**Comments and Proposed Alternative by Dan Johnson**  
**Albany Resident, Beach User, Bay Trail Commuter Cyclist**  
4/16/17

**Albany Beach Restoration and Public Access Project at Eastshore State Park – Phases 2 and 3**  
**BCDC Permit Number 2014.005.01**  
**Exhibit package dated 4/17/17**

BCDC DESIGN REVIEW BOARD: APRIL 17, 2017

## ALBANY BEACH RESTORATION AND PUBLIC ACCESS PROJECT: PHASES 2 & 3 AT MCLAUGHLIN EASTSHORE STATE PARK

Figure 5

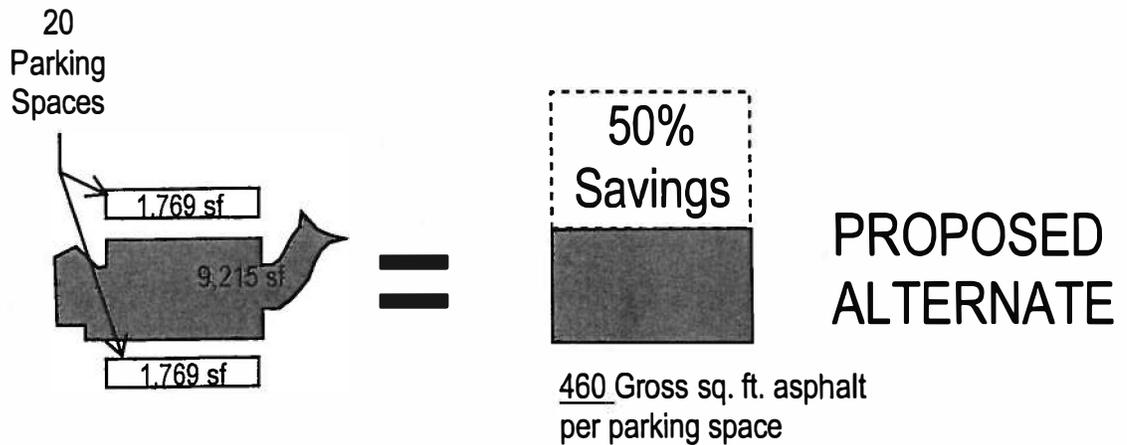
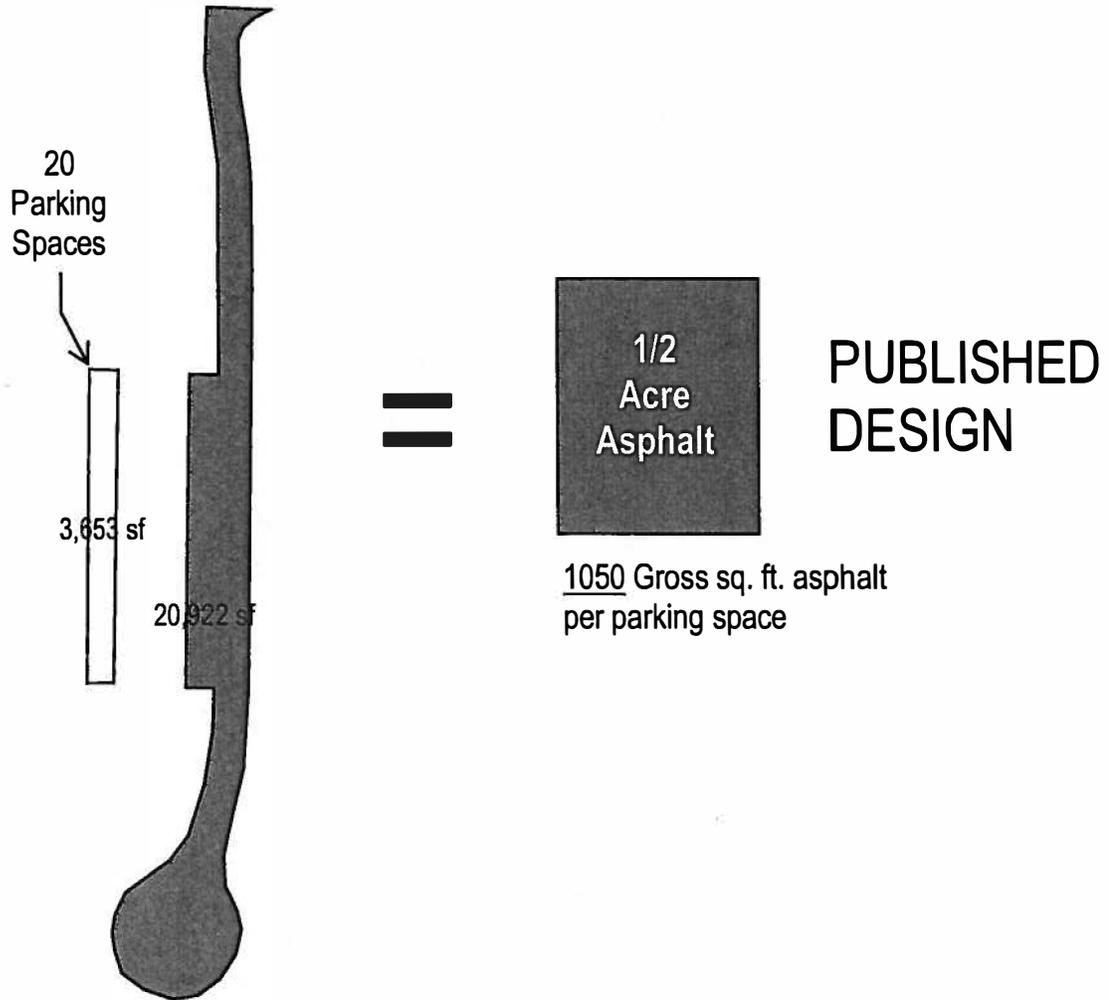
# TOO MUCH ASPHALT
